## Central Sydney Planning Committee

- 1. Disclosures of Interest**
- 2. Confirmation of Minutes**
- 3. Matters Arising from the Minutes**
- 4. Development Application - 420 & 422-424 Kent Street and 275 & 277 Clarence Street, Sydney - D/2018/1577**

**Figure 13:** Kent Street elevation and the extent of the modulated cantilever as originally proposed.

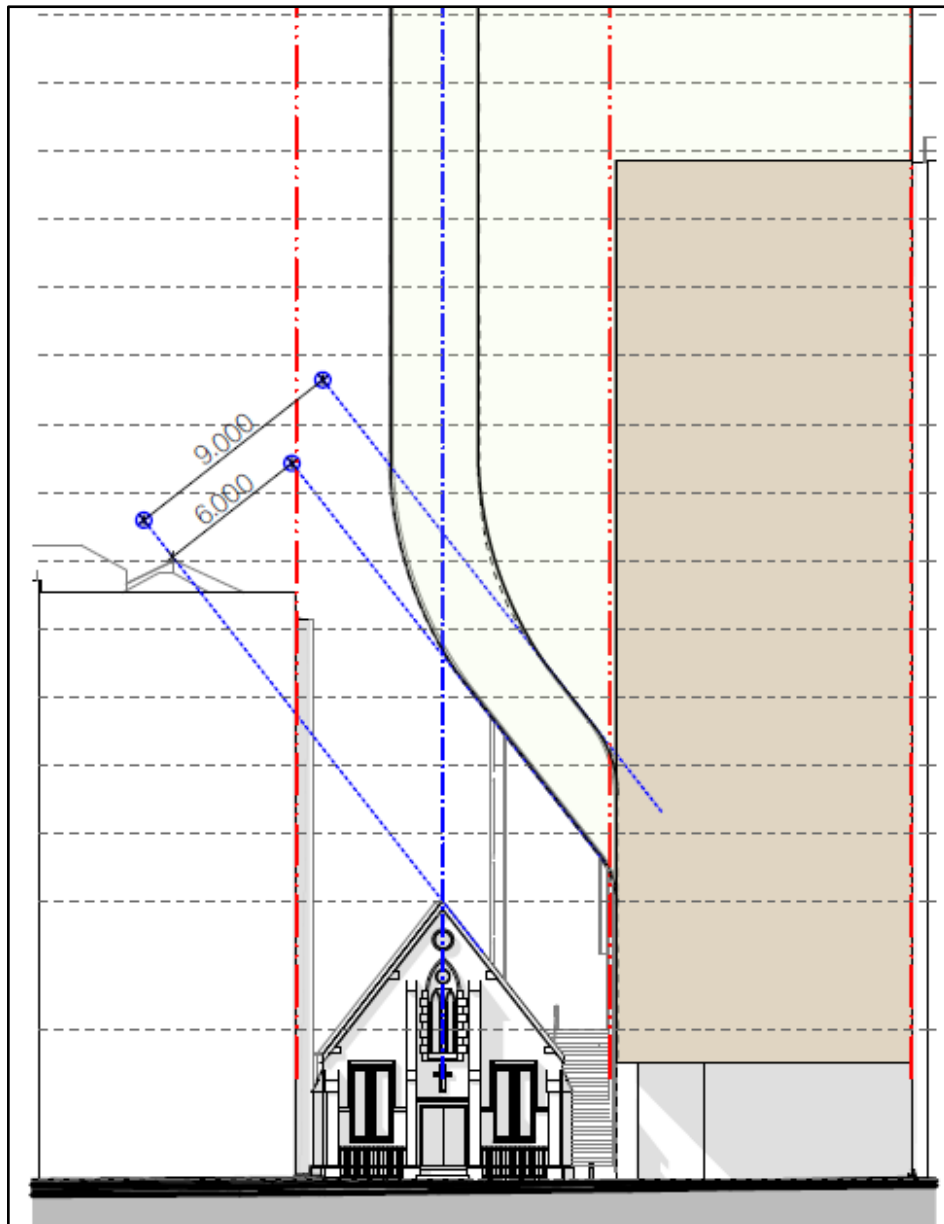
- (a) The degree of cantilever was considered to be excessive and overwhelmed the curtilage and significance of the heritage building. It was recommended that the outer cantilever mass be amended and therefore, the internal hotel configuration be replanned.

**Figure 14:** Kent Street elevation and the reduced extent of the modulated cantilever (increasing the separation of the underside of the cantilever and realignment of the outer edge with the apex of the Genesian Theatre roof), as proposed to the CSPC.

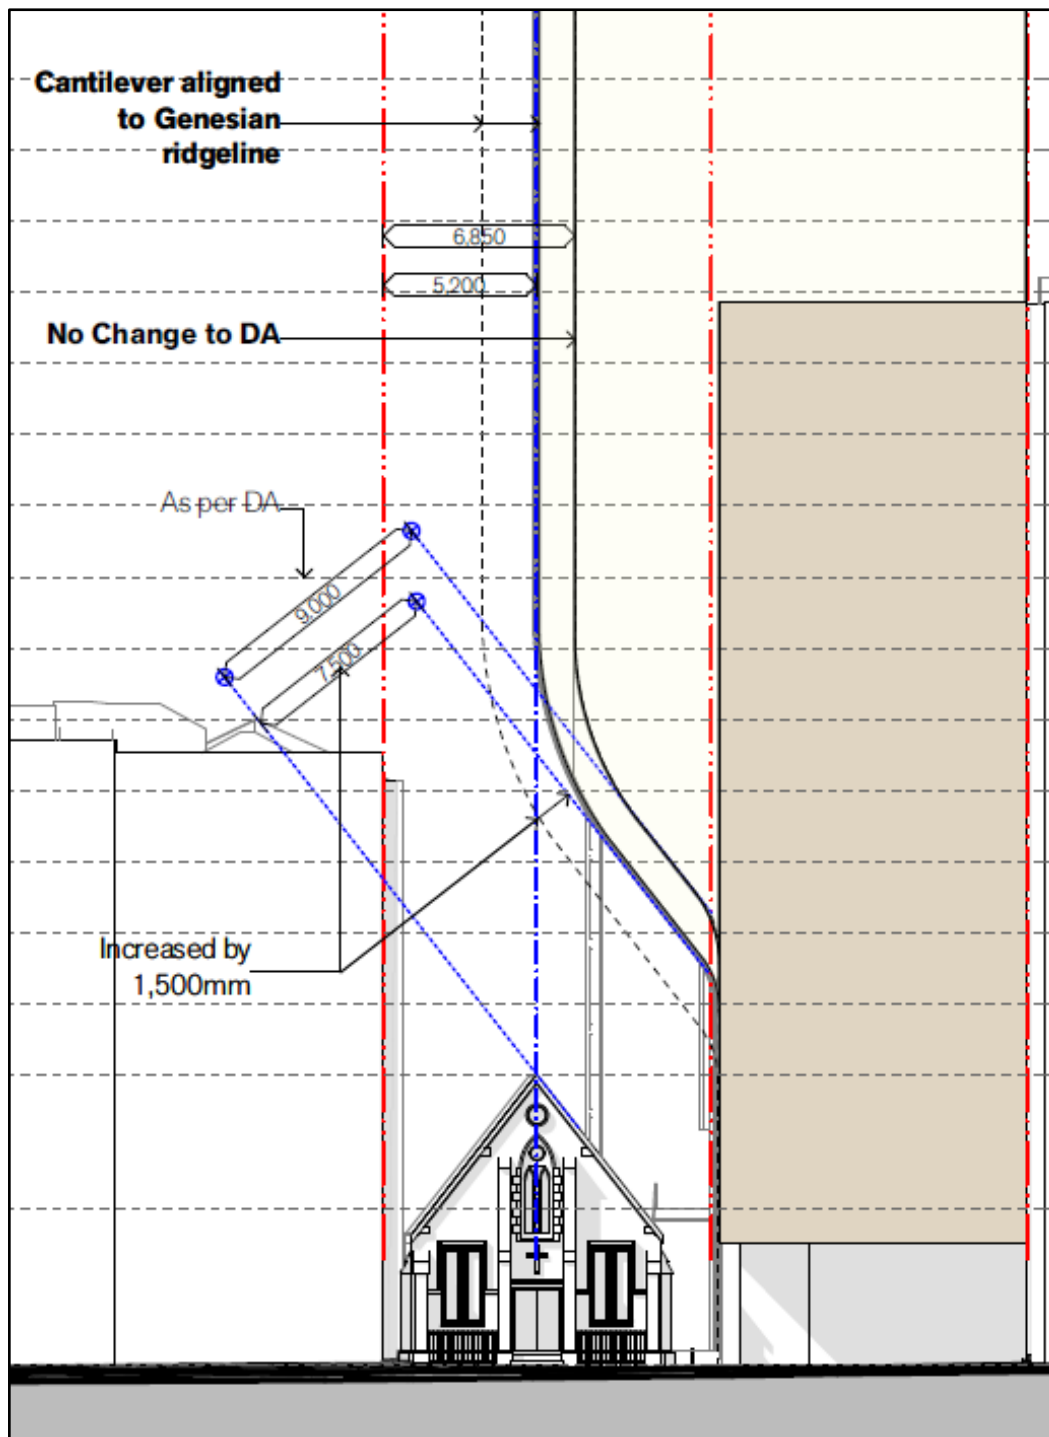
22. Accordingly, the CSPC resolved to defer the determination of the application to enable the preparation of an amended proposal that addressed the concerns relating to the cantilevered design and distribution of floor space within the tower. The CSPC also indicated that they may waive the requirement for a design competition and preparation of a site-specific development control plan or Stage 1 application in the case that the proposal exceeds 55m in height, provided it does not breach other controls.
